Draft REPORT

11th meeting of GRRF Informal Working Group on Automatically Commanded Steering Function

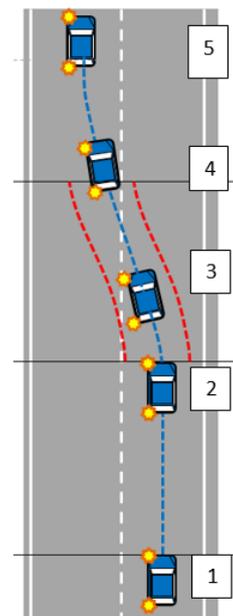
Discussion about the moment to switch off the turn indicator.

(NL): Believes, that the turn indicator lamps should stay on until CAT B1 has stabilized the vehicle in the lane (“5”).

(UK): Personally, he would switch off the turn indicator lamps at point “4”, but he will clarify this UK-internally.

(UK): We have to avoid, that the vehicle moves to the lane edge after “1”, because then the lane change manoeuvre has started already.

Homework: OICA to make a new proposal on the definitions
